Transport Response

Dover Road, Walmer, Kent

Iceni Projects Limited on behalf
of Gladman Developments

1. RESPONSE TO 13TH JULY 2017 HIGHWAY COMMENTS

TITLE
2022 GROWTH AM

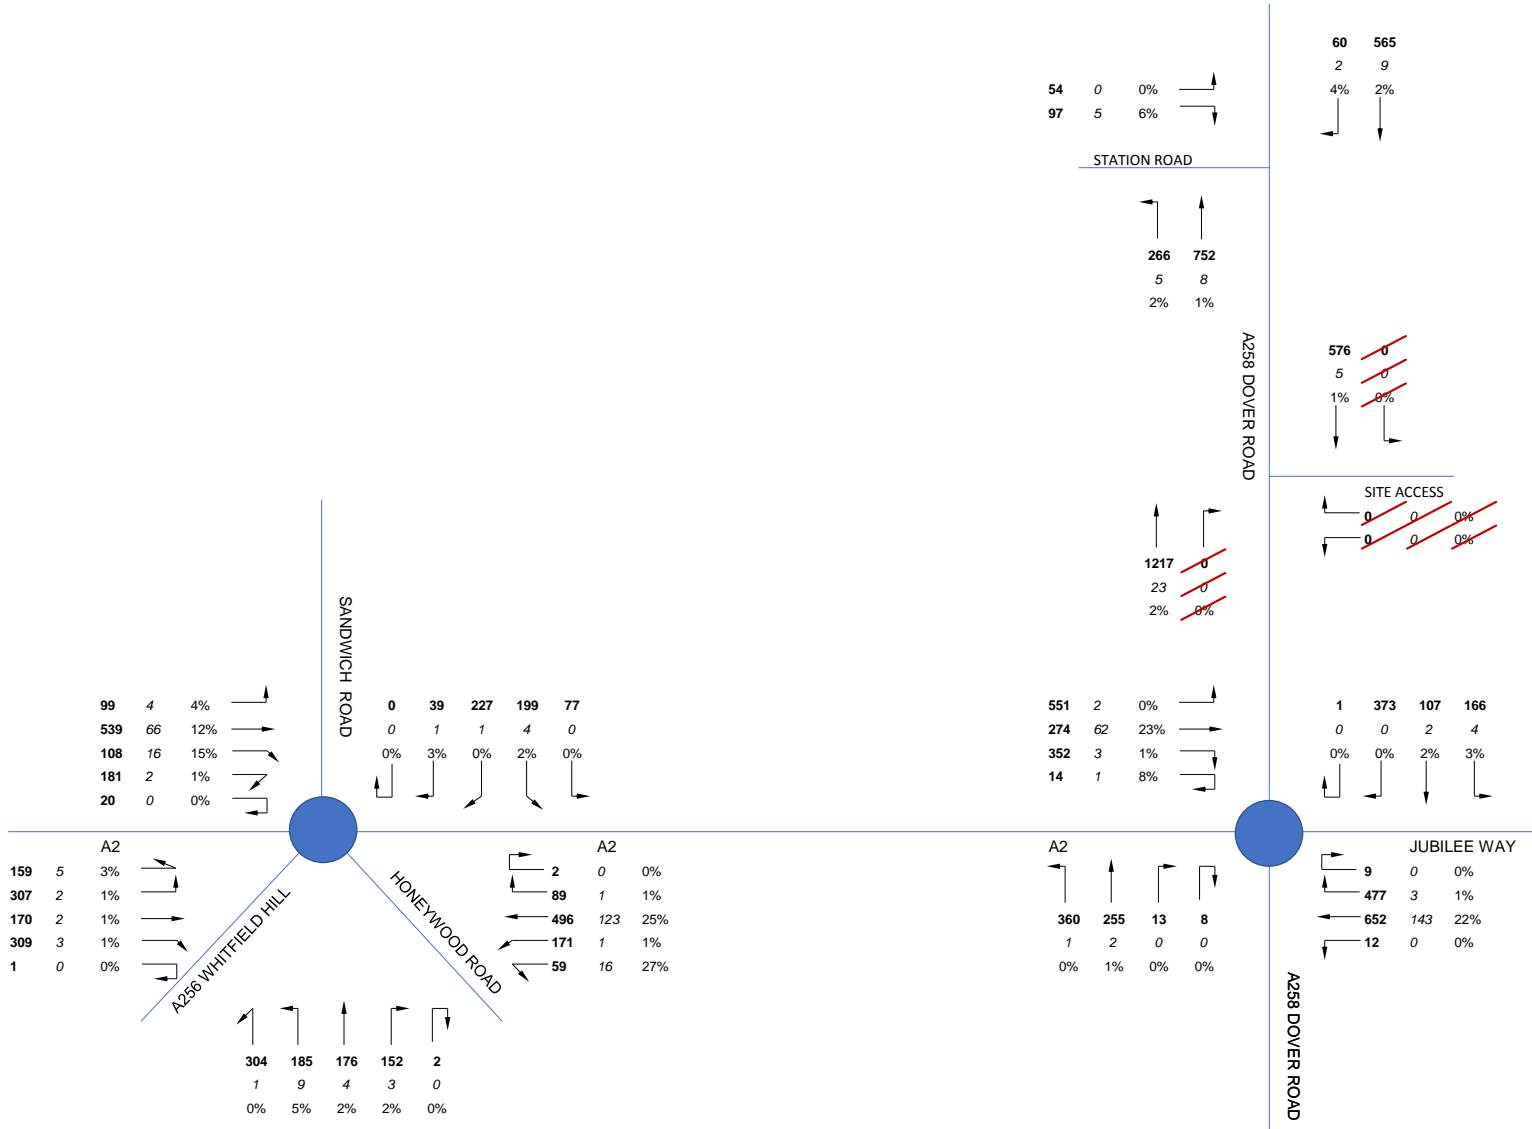
It is not clear how the 2022 base and 2022 development figures have been derived. I wish to see additional flow diagrams giving a breakdown of the TEMPRO, committed development and proposed development trips added.

- 1.9 This data is provided with this note at **Appendix A5**.

A7. JUNCTION GEOMETRIES

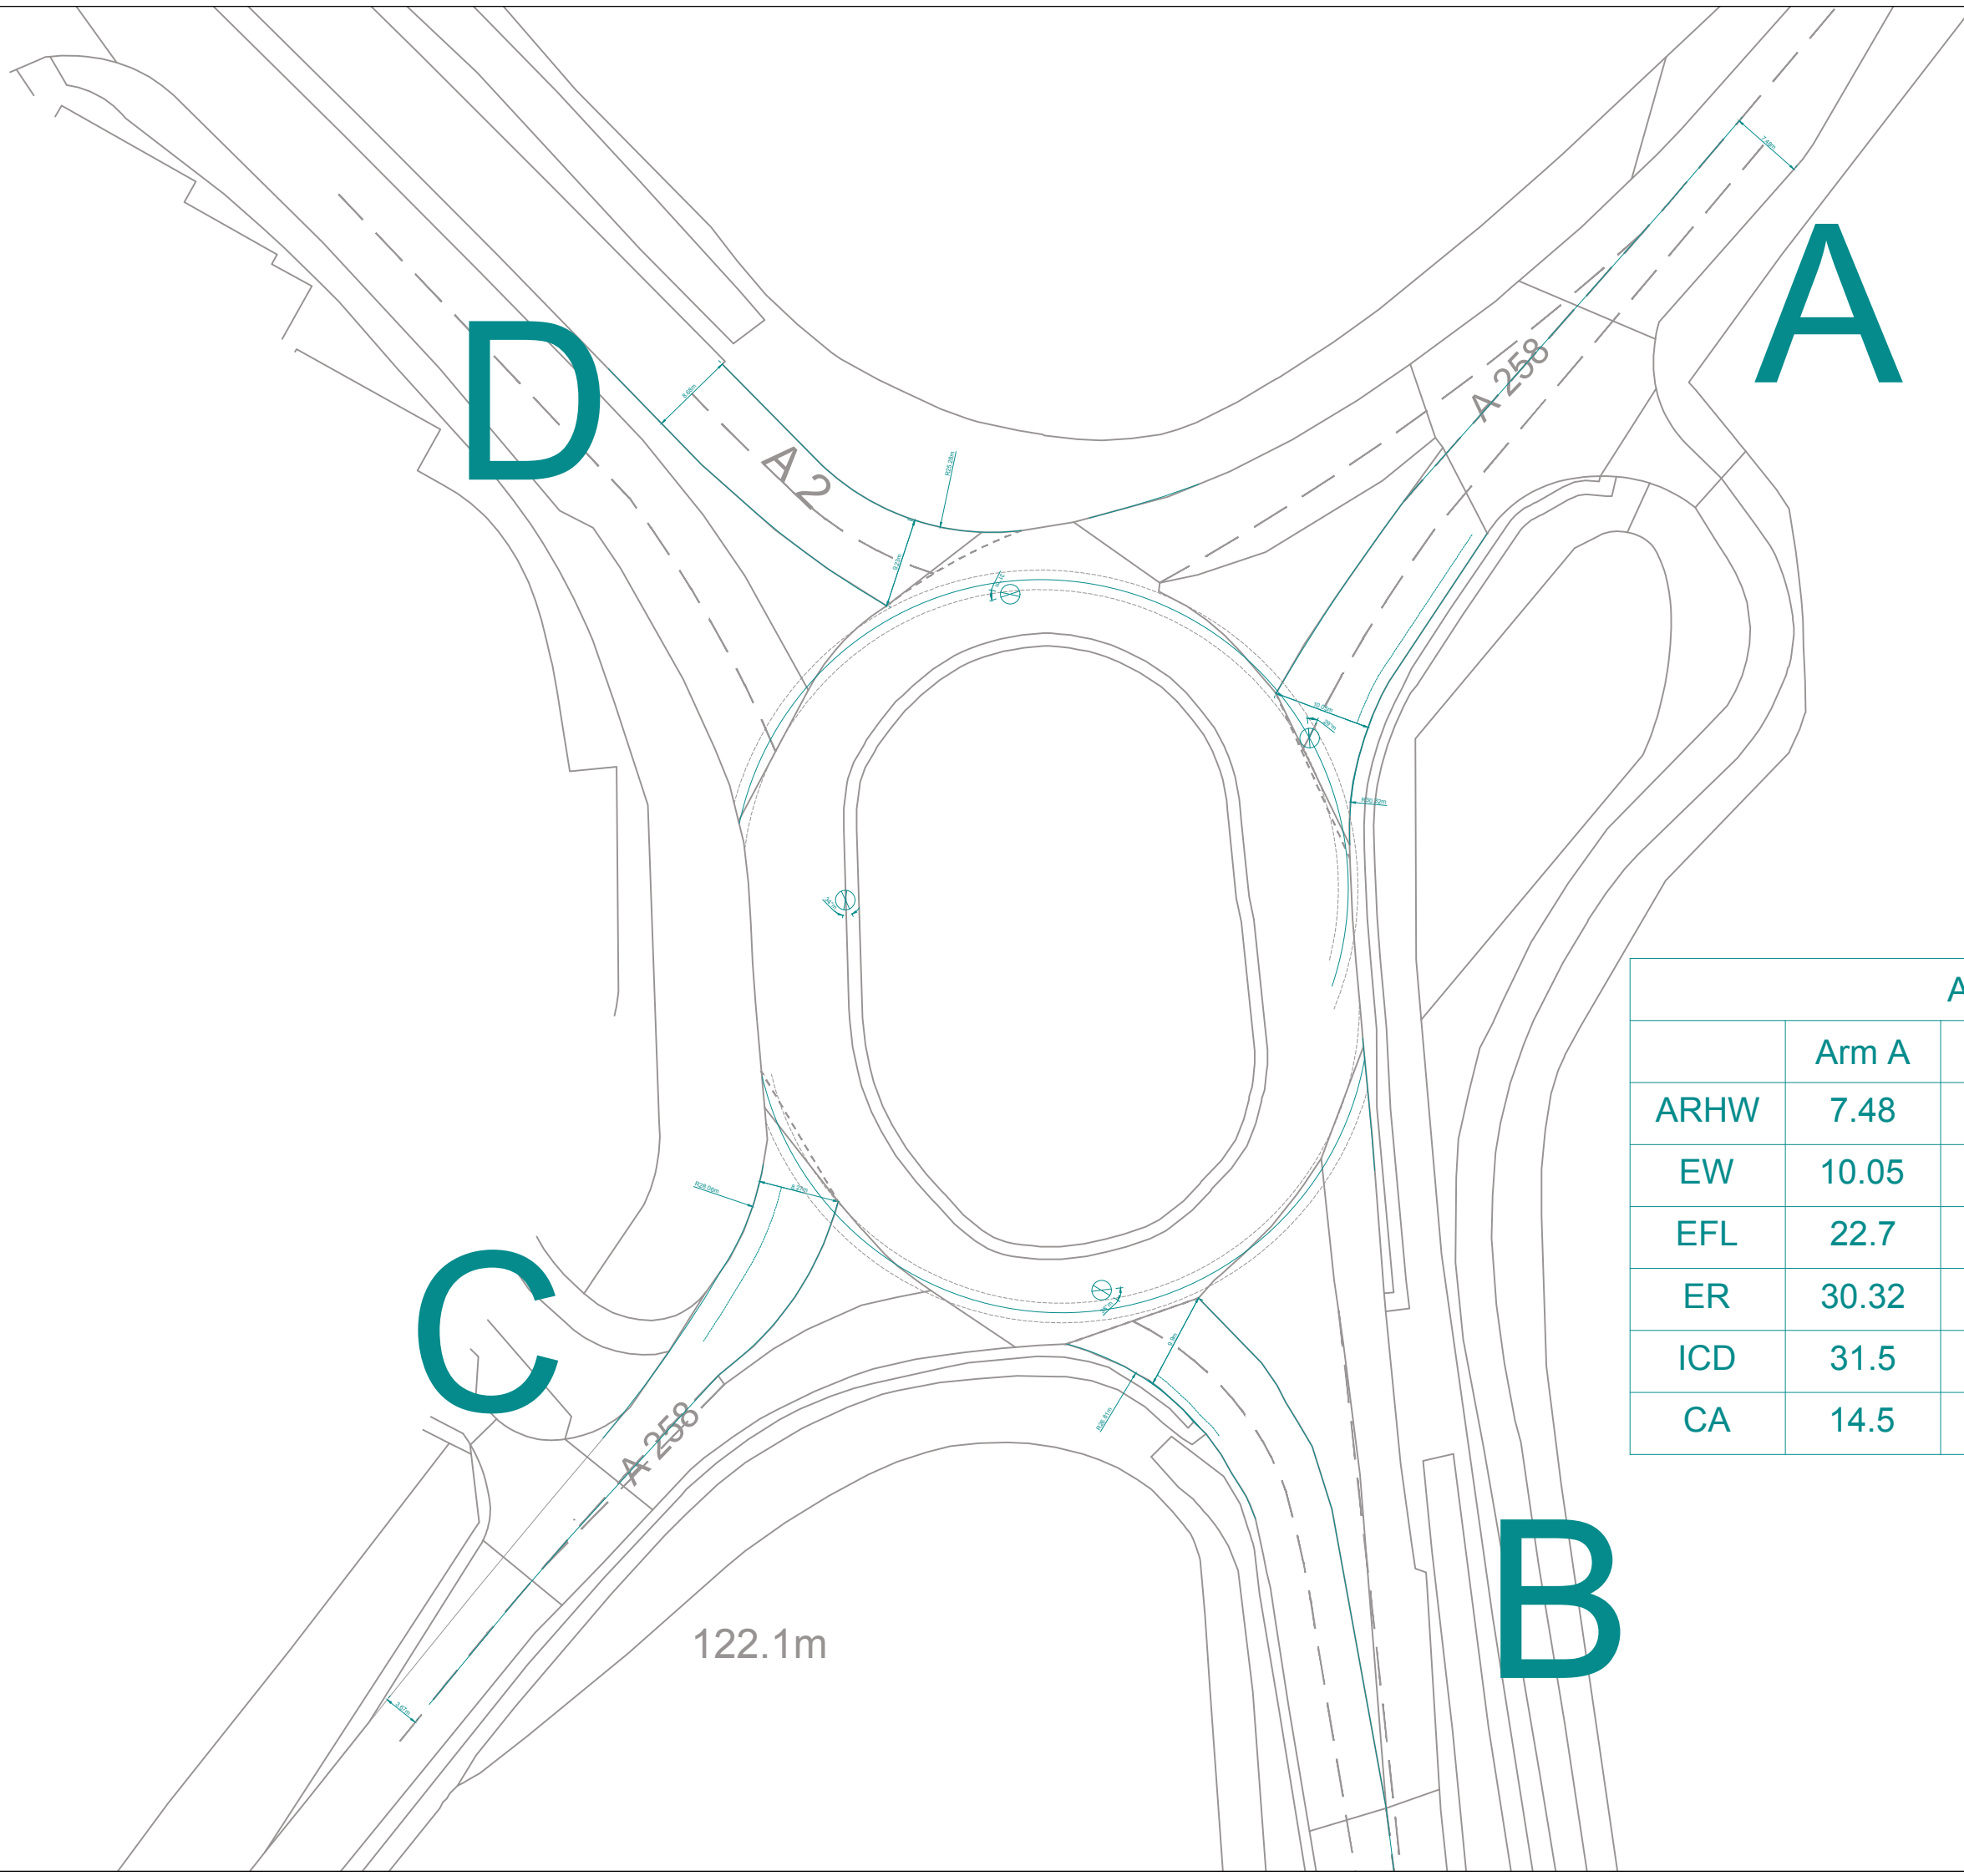
The Duke of York roundabout assessment appears to use mostly incorrect dimensions. These should be checked and a plan showing the dimensions submitted. The 2017 observed flows assessments appear to use greater demand flows than those provided in the flow diagrams and in the counts, in some cases it appears as many as 30-40 additional movements (for example A-B movement in am peak is shown as 363 on flow diagram but the demand used appears to be 396). Proposals for Whitfield Urban Expansion Phase 2 are now well advanced and the junction should therefore also be modelled with and without the associated trips from this development. The planning permission for Whitfield Urban Expansion Phase 1 (ref: DOV/10/01010) includes a contribution for improvements at the roundabout which essentially provides three arms on the A258 (N) approach and round to the A2 (S) exit (a concept plan is included in the Transport Assessment dated June 2011). This should be included in the future year assessment of the junction. I understand the roundabout dimensions and modelling concepts for this roundabout have been agreed with Highways England for WUE Phase 2 so you may want to check this and then align your modelling accordingly, but I would advise you to discuss this with Highways England. It doesn't appear you have asked HE to comment on your current Highways Assessment document and I would therefore advise that you do, to avoid any subsequent abortive work. Clearly all of the above, particularly the incorrect dimensions and flow numbers, will require re-modelling of the junction.

- 1.15 Finally, the geometries calculated at the existing junction are deemed correct and that our assessment of the existing layout is accurate and is shown at **Appendix A6**.
